Access Compliance Report

Public Rights-of-Way

Intersection ID: 27531	Main Street: BALLANTYNE COMMONS PY	Cross Street: PLANTATION PARK BV	Location:	E
ADA ID: FD8473A48D96	Ramp Type: Perp	Initial Pass/Fail: Fail	Overall Compliance: No	Severity Score: 25
Codes/Mitigation Info/Possible Solution		Field Measurements/Component Compliance

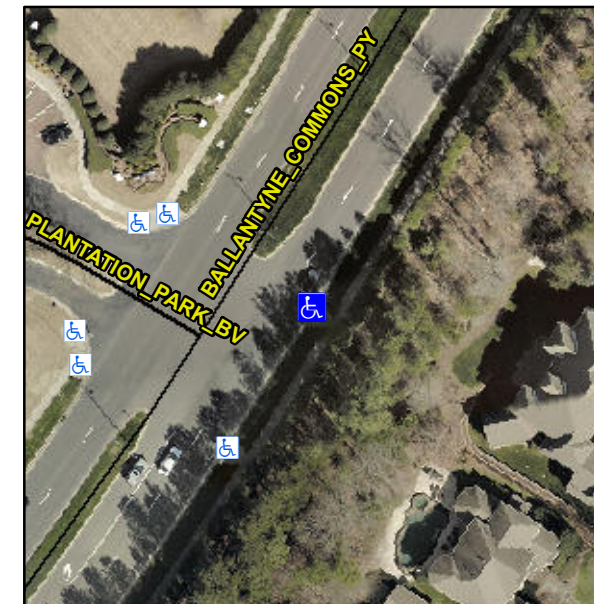
Not Found, R304.5.3

Compliance	Description	Data	Compliance	Description	Data
N/A	Ramp Length (in)	118.0	Yes	Ramp Slope (%)	7.9
Yes	Ramp Width (in)	48.0	No	Ramp XSlope (%)	10.8
N/A	Flare Type LT	N/A	N/A	Flare Type RT	N/A
N/A	Flare Slope LT (%)	N/A	N/A	Flare Slope RT (%)	N/A
N/A	Flare Traversable LT?	N/A	N/A	Flare Traversable RT?	N/A
N/A	Landing Length (in)	N/A	N/A	DWS Provided?	N/A
N/A	Landing Width (in)	N/A	N/A	DWS Contrast?	N/A
N/A	Landing Slope (%)	N/A	N/A	DWS Length (in)	N/A
N/A	Landing X Slope (%)	N/A	N/A	DWS Full Width?	N/A
N/A	Landing Curb? (Y/N)	N/A	N/A	DWS Offset (in)	N/A
N/A	Shared Landing?	N/A			
N/A	Gutter Ponding?	N/A	N/A	Gutter Slope (%)	N/A
N/A	Gutter Lip Ht (in)	N/A	N/A	Gutter X Slope (%)	N/A
N/A	Painted X Walk1?	No	N/A	Painted X Walk2?	N/A
	X Walk 1 Direction	To NW		X Walk 2 Direction	N/A
N/A	X Walk 1 Width (in)	N/A	N/A	X Walk 2 Width (in)	N/A
	X Walk 1 Slope (%)	2.1		X Walk 2 Slope (%)	N/A
	X Walk 1 X Slope (%)	7.4		X Walk 2 X Slope (%)	N/A

Remove & Replace Entire Ramp.
